**ADDENDUM 01 TO BID DOCUMENTS FOR THE  
HWY. 384 HYDROLOGIC RESTORATION PROJECT  
MAINTENANCE EVENT (CS-21)  
CAMERON PARISH, LOUISIANA**

**May 21, 2015**

**LOUISIANA COASTAL PROTECTION AND RESTORATION AUTHORITY**

**ADDENDUM 01 TO BID DOCUMENTS  
HWY 384 HYDROLOGIC RESTORATION PROJECT (CS-21)**

**CS-21-SM-01 MONUMENT DATA SHEET**

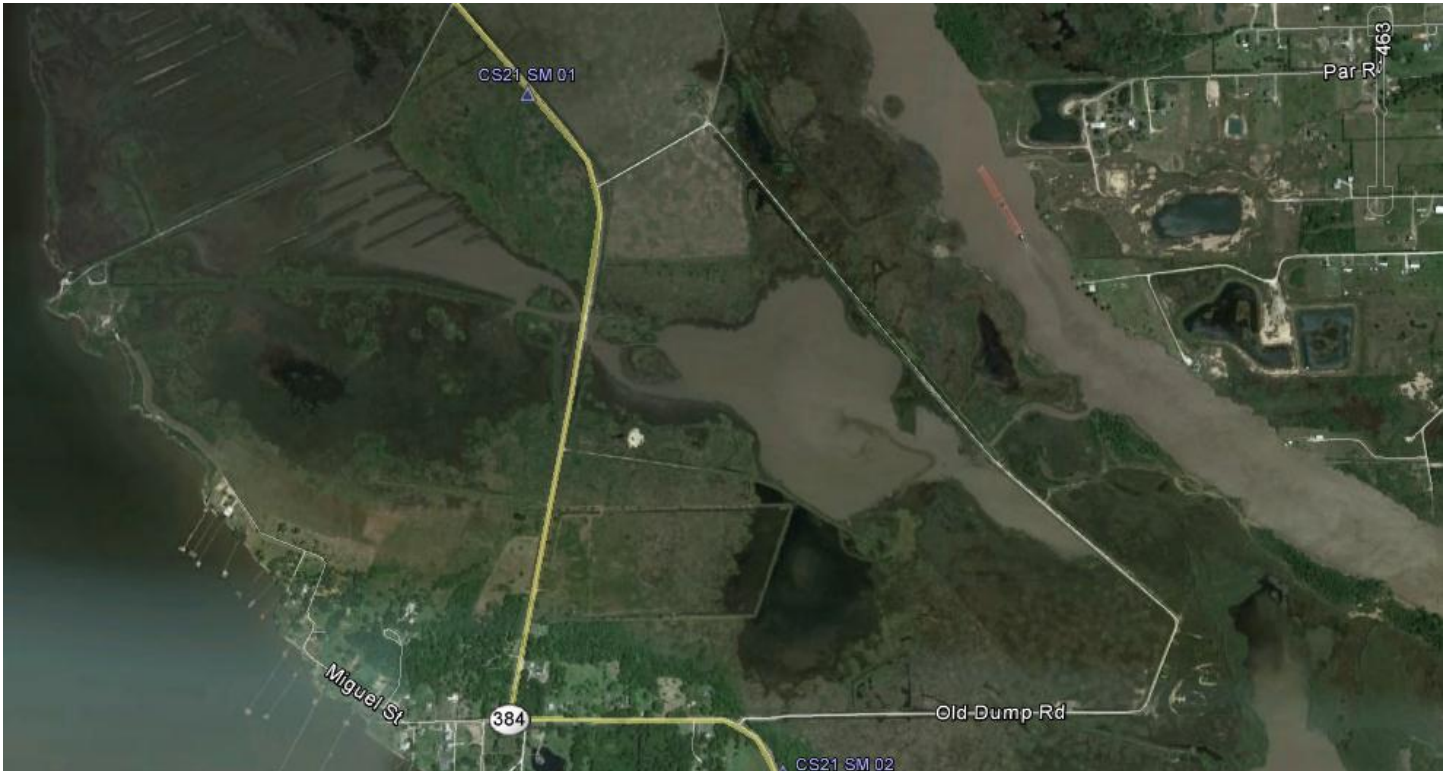
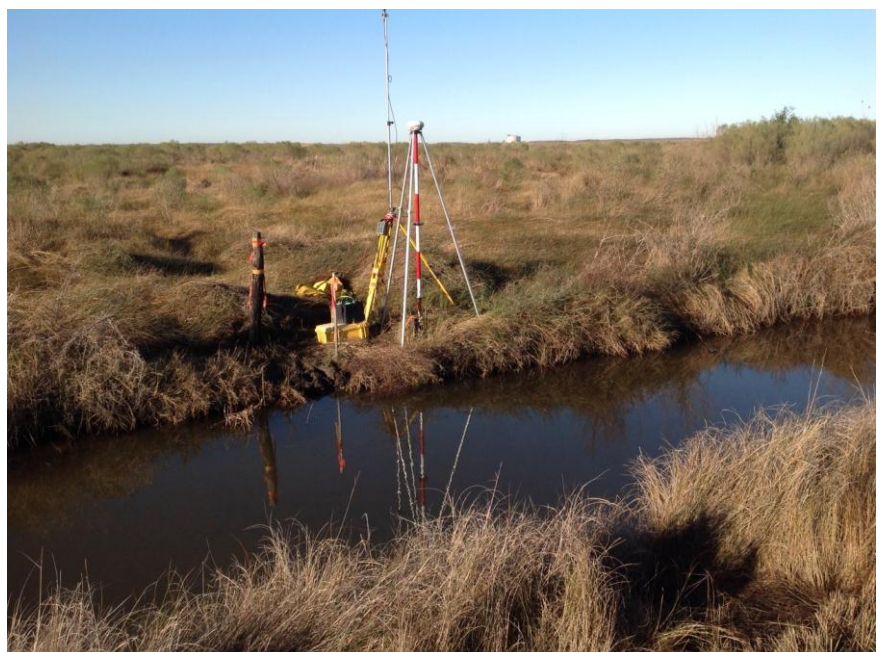
**Remove:** CS-21-SM-01 Monument Data Sheet in Appedix D of the Specifications

**Replace with:** Attachment 1 in this Addendum.

ATTACHMENT 3  
SHEET 3-REV.1

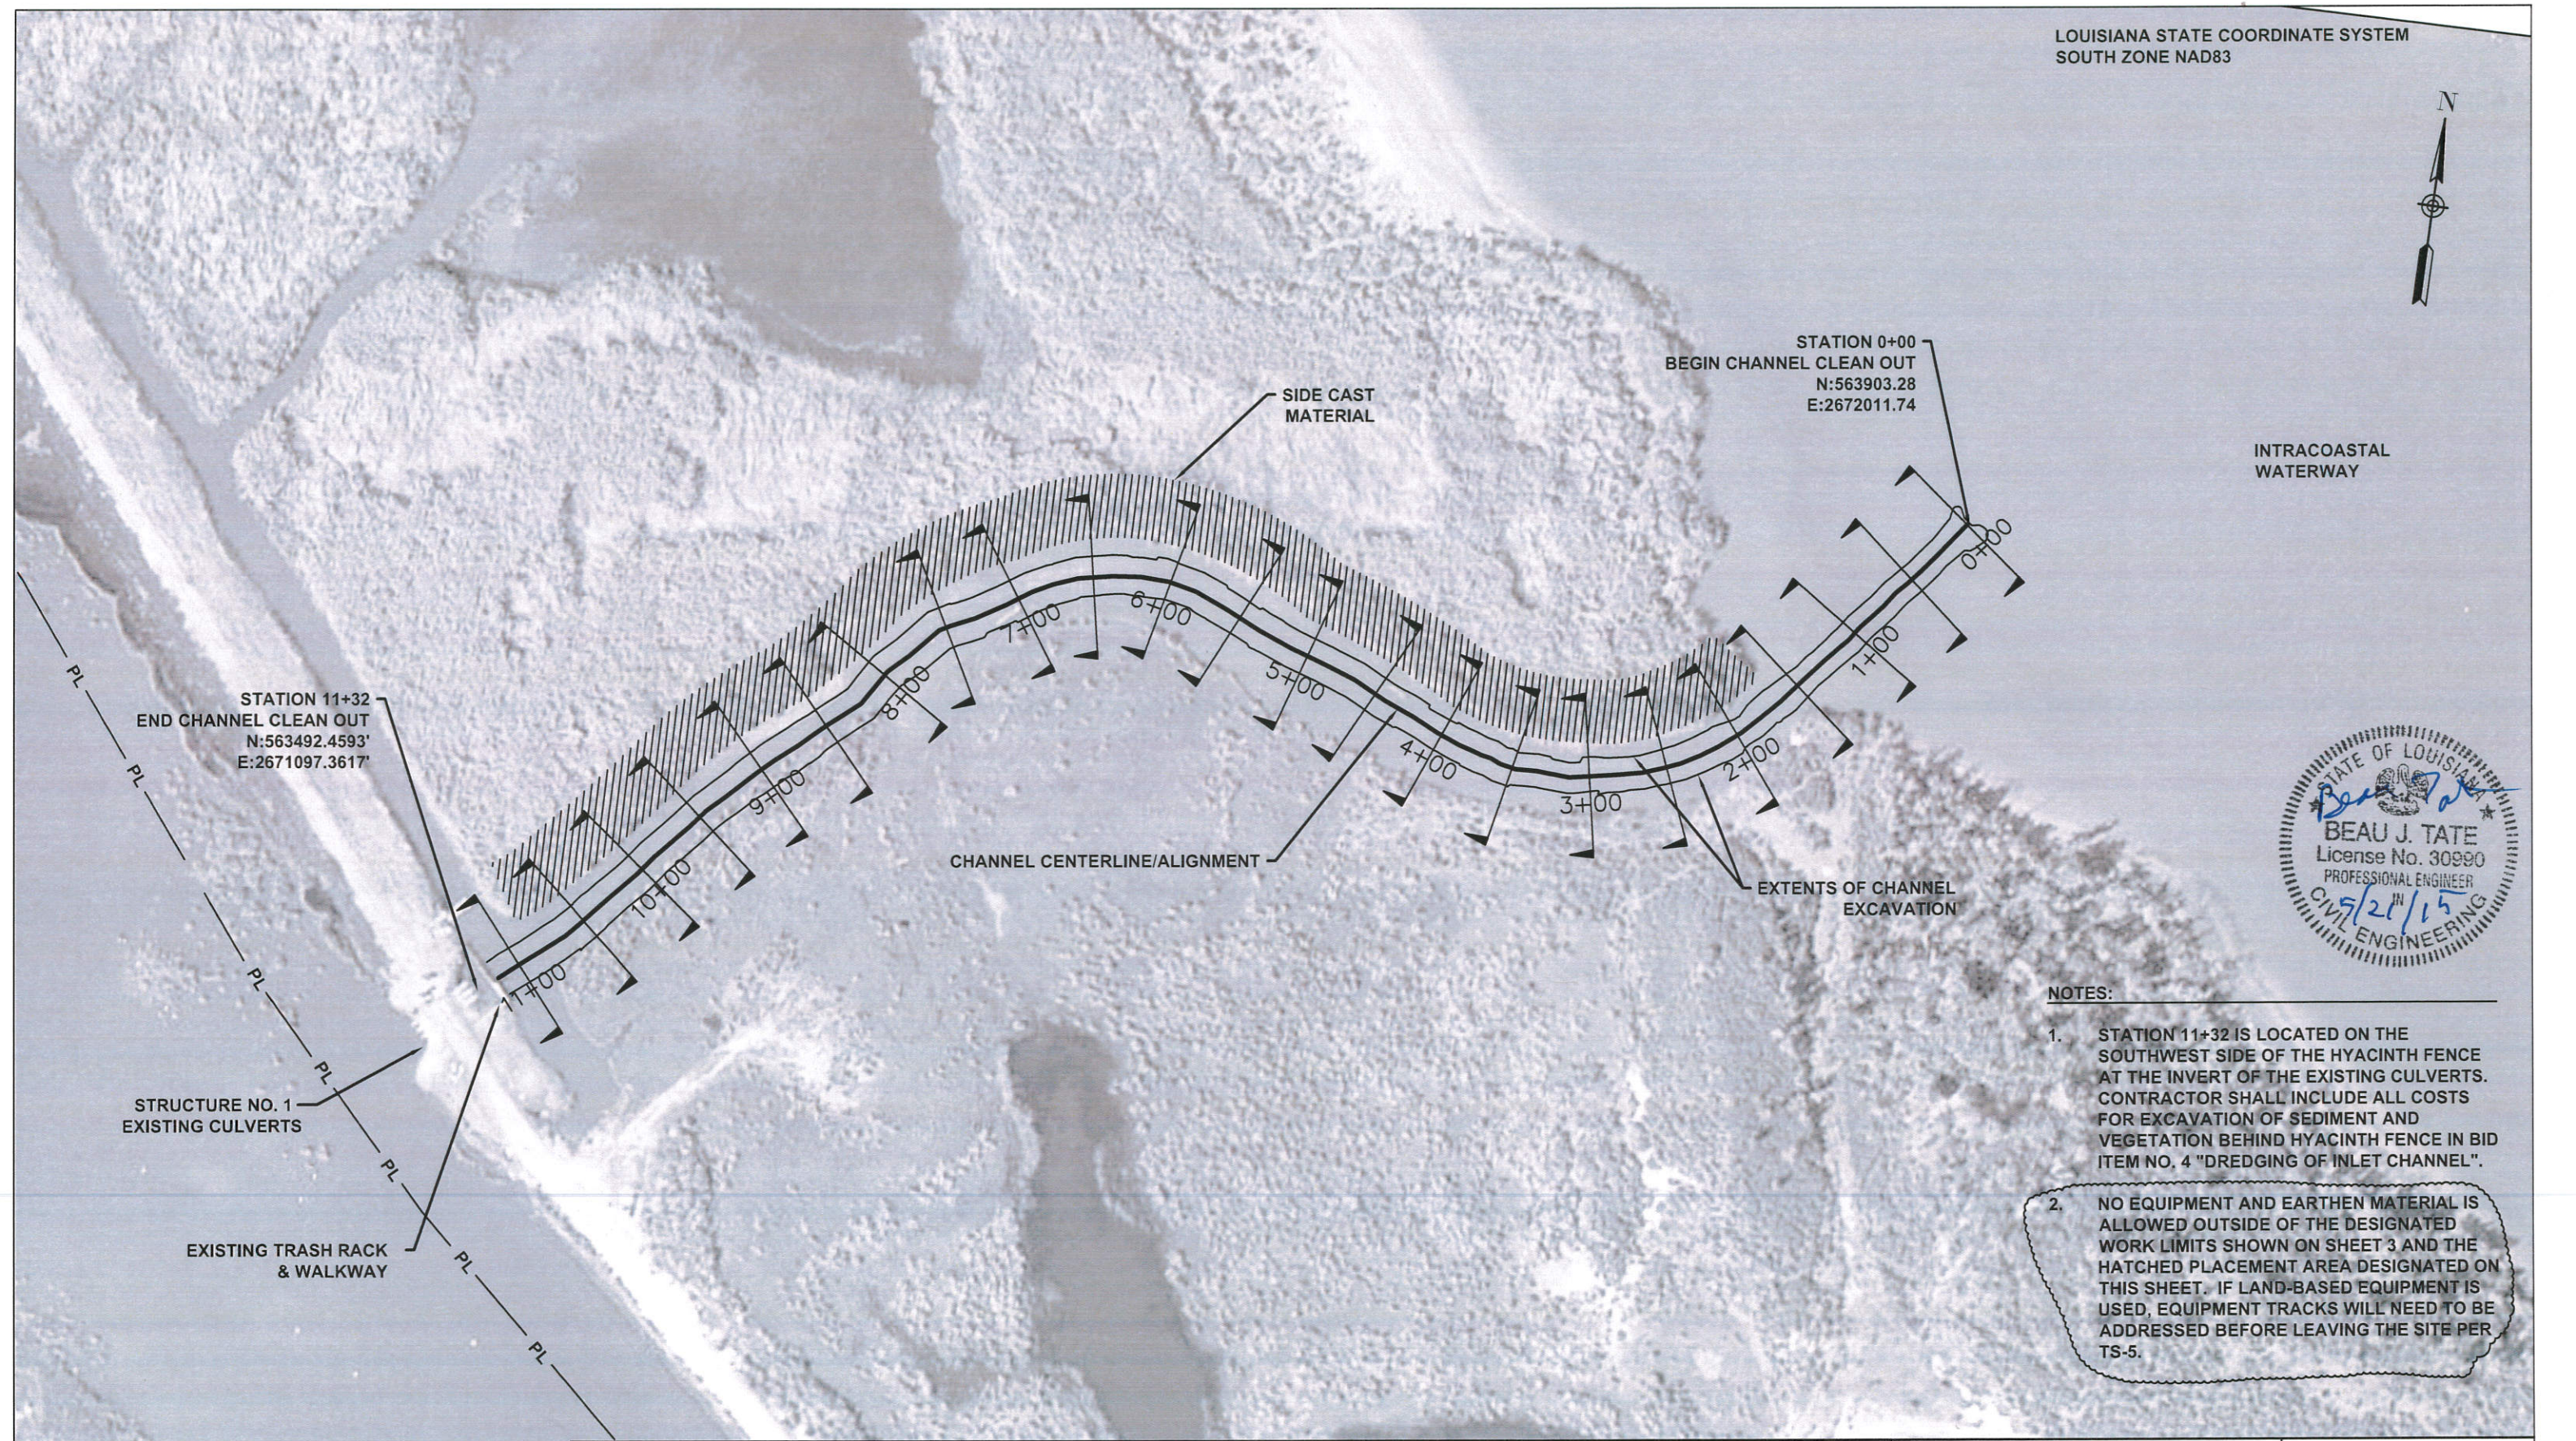
WORK LIMITS EXTENDED TO EXTENTS  
OF SIDECAST PLACEMENT AREA

NOTE 6 REMOVED
